Access Compliance Report

Public Rights-of-Way

(Curb Ramps)

Intersection ID: 16141	Main Street: N_WENDOVER_RD	Cross Street: LATROBE_DR	Location: SW
ADA ID: 2A4DEA06C405	Ramp Type: Perp	Initial Pass/Fail: Fail	Overall Compliance: No
Severity Score: 22.5			
Codes/Mitigation Info/Possible Solution		Field Measurements/Component Compliance

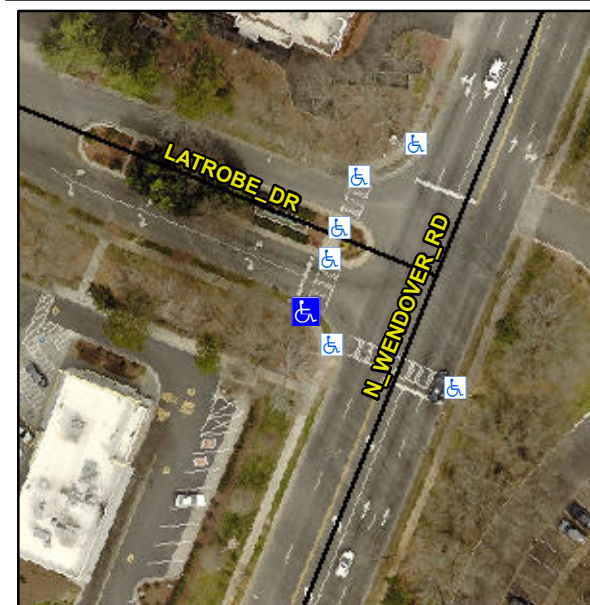
Not Found, R304.5.1, R304.2.2

Compliance	Description	Data	Compliance	Description	Data
N/A	Ramp Length (in)	52.0	No	Ramp Slope (%)	10.1
No	Ramp Width (in)	42.0	Yes	Ramp XSlope (%)	2.6
N/A	Flare Type LT	N/A	N/A	Flare Type RT	N/A
N/A	Flare Slope LT (%)	N/A	N/A	Flare Slope RT (%)	N/A
N/A	Flare Traversable LT?	N/A	N/A	Flare Traversable RT?	N/A
N/A	Landing Length (in)	N/A	N/A	DWS Provided?	N/A
N/A	Landing Width (in)	N/A	N/A	DWS Contrast?	N/A
N/A	Landing Slope (%)	N/A	N/A	DWS Length (in)	N/A
N/A	Landing X Slope (%)	N/A	N/A	DWS Full Width?	N/A
N/A	Landing Curb? (Y/N)	N/A	N/A	DWS Offset (in)	N/A
N/A	Shared Landing?	N/A			
N/A	Gutter Ponding?	N/A	N/A	Gutter Slope (%)	N/A
N/A	Gutter Lip Ht (in)	N/A	N/A	Gutter X Slope (%)	N/A
N/A	Painted X Walk1?	Yes	N/A	Painted X Walk2?	N/A
	X Walk 1 Direction	To NE		X Walk 2 Direction	N/A
N/A	X Walk 1 Width (in)	111.0	N/A	X Walk 2 Width (in)	N/A
	X Walk 1 Slope (%)	9.8		X Walk 2 Slope (%)	N/A
	X Walk 1 X Slope (%)	3.1		X Walk 2 X Slope (%)	N/A

Remove & Replace Entire Ramp.
